I am an Aldington Resident and have been unable to submit my objection to the planning application for the East Stour Solar Farm 22/00668/AS to the new portal, so please see my objection below and can you kindly confirm receipt and that it has been posted on the website comments section.

Church Lane Residents Group – LETTER OF OBJECTION

EDF Application Plan: Green line inserted showing panel area to be removed on south facing slope of Bested Hill

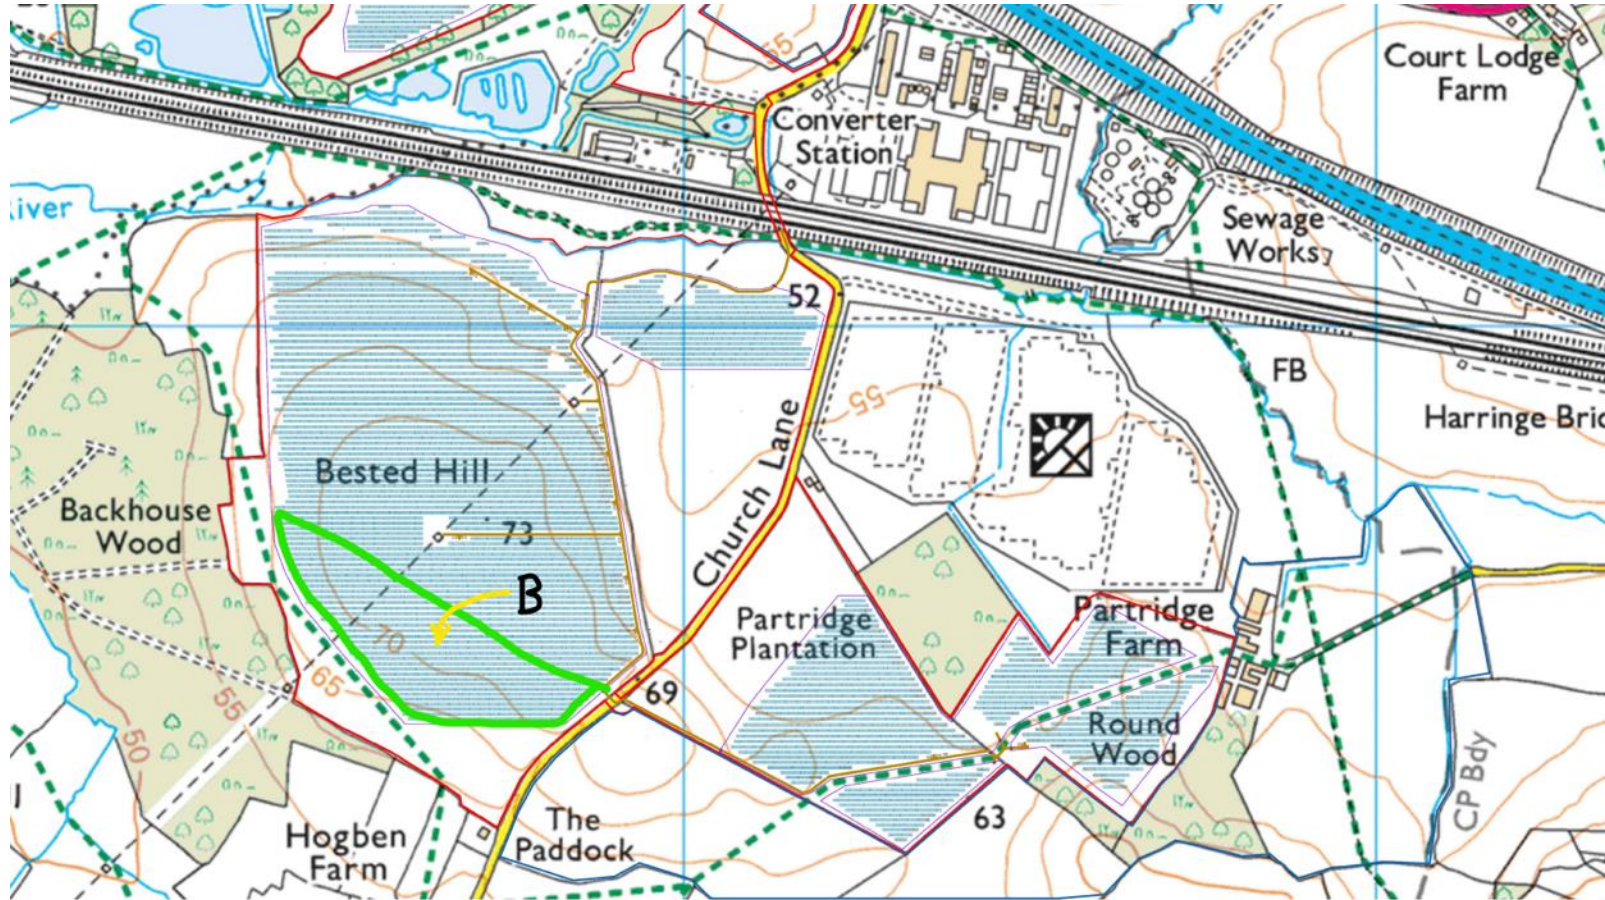
7. This slide shows the EDF planning application plan (southern element of the scheme only) on which we have superimposed verged green the area of panel footprint that needs to be removed. Note that the new southern boundary to the panel footprint is the projection of the northern boundary of the point-to-point course on the other side of the lane.
